NPDES PERMIT FACT SHEET
INDIVIDUAL INDUSTRIAL WASTE (IW)
AND IW STORMWATER

Application No. PA0246891
APS ID 460282
Authorization ID 1210157

| Purpose of Application | Renewal of Individual Permit to Discharge Industrial Stormwater. | | |

(Updated OBOD Drainage FIGURE A-4 in response to questions 1.a.3; 2.a.2; and 3.a. in PADEP 2/28/2022 email)

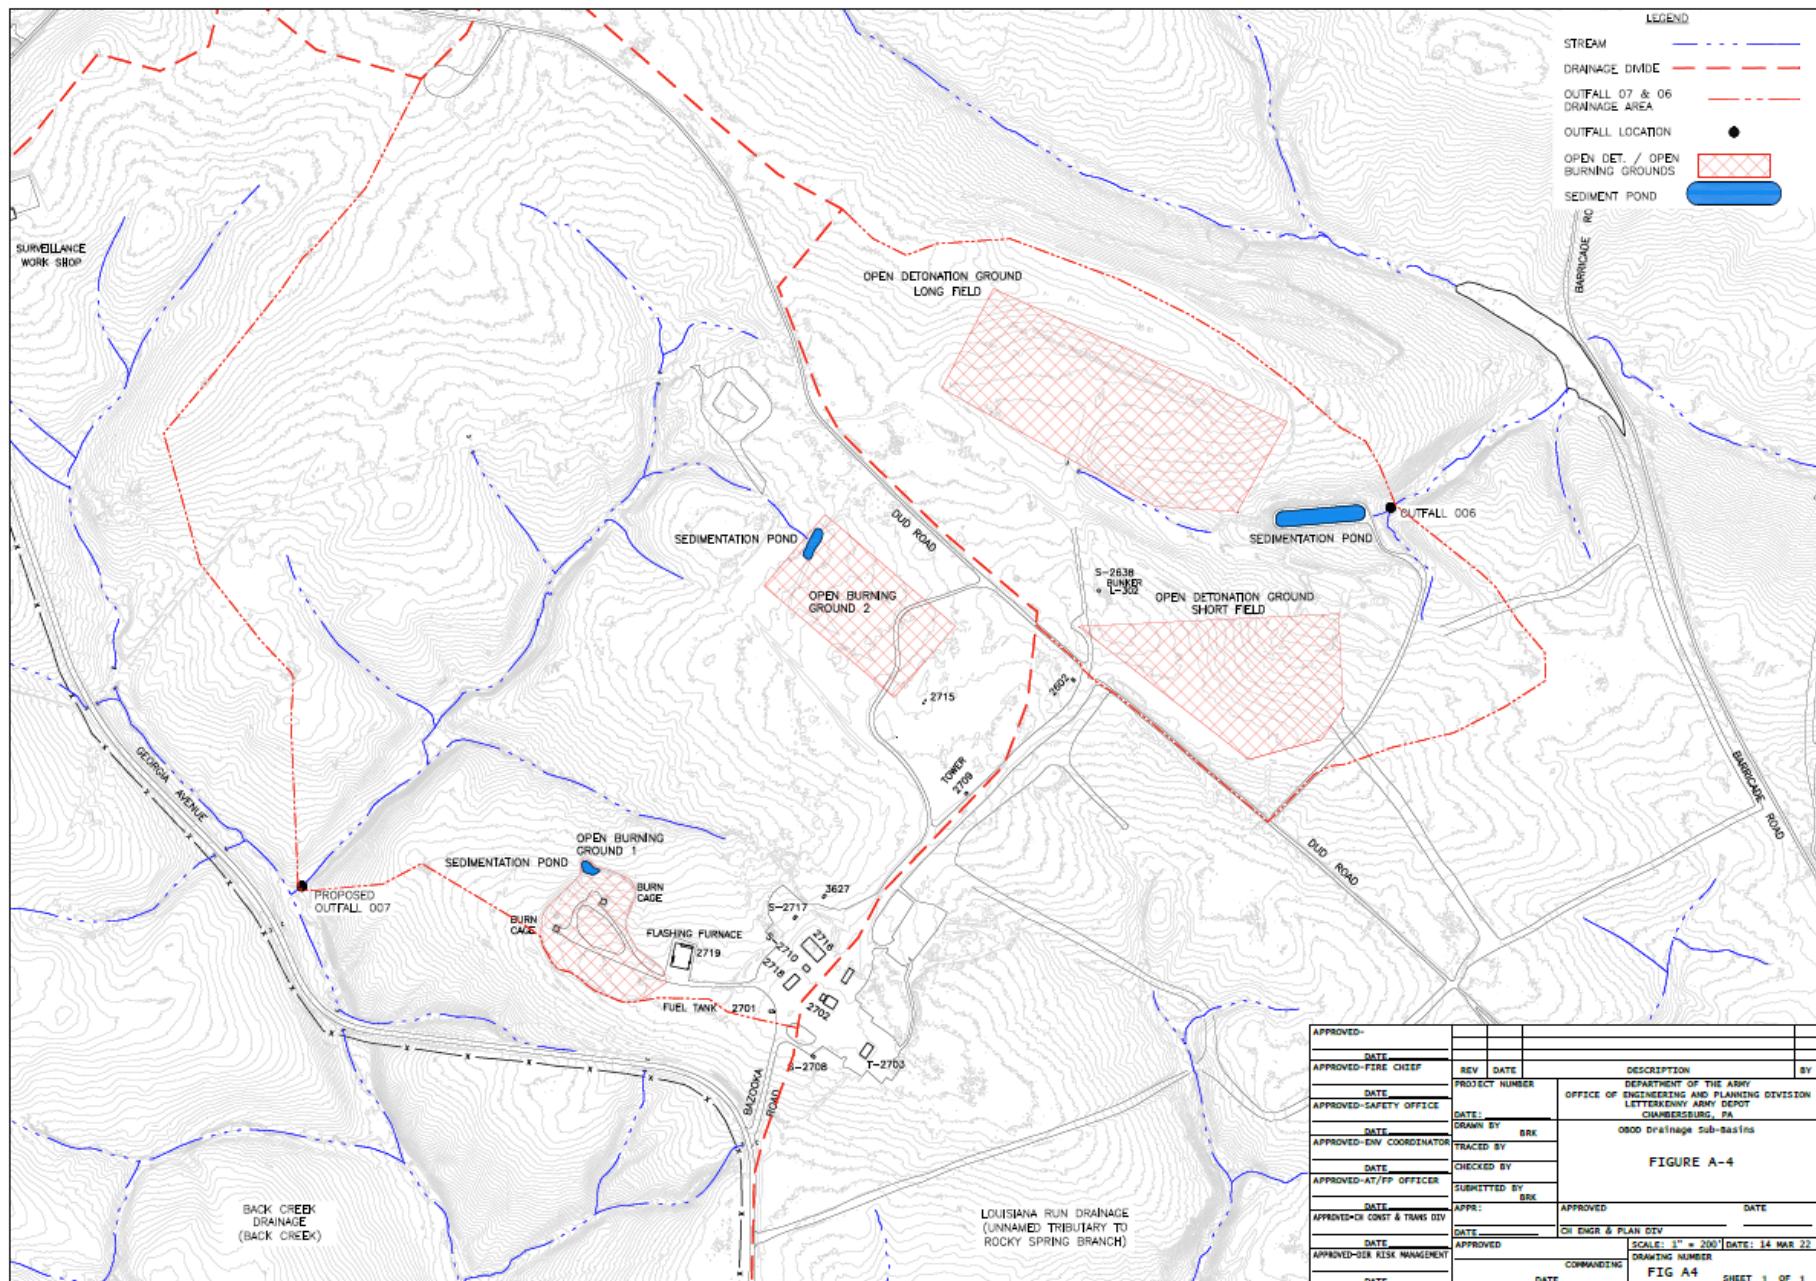
The stormwater from OB Grounds 1 and 2 flows to a tributary of Back Creek.
 2. It appears there should be another outfall identified and labeled for the discharge from the sedimentation pond located at OB Ground 2 shown on Figure A-4 (attached). Please elaborate and provide updated maps and application pages as necessary.

a. **Provide a revised Figure A4 (or a new figure) that clearly outlines the drainage areas for Outfall 006 and Outfall 007, so it is easier to see which areas drain to each outfall. Include any necessary additional outfalls to ensure the entire area is capture by an identified outfall.**

LEAD recommends a stormwater outfall that will capture flow from the sedimentation ponds at both Open Burning (OB) Grounds 1 and 2. See attachment titled OBOD Drainage – FIGURE A-4 that shows the location of the proposed outfall.
 3. If the flashing furnace is the only area that drains to Outfall 007, how does the drainage area for Outfall 007 reach 409,077 sq. feet as indicated in the application?

See attachment titled OBOD Drainage – Figure A-4, which outlines the drainage areas for Outfall 006 and Outfall 007.
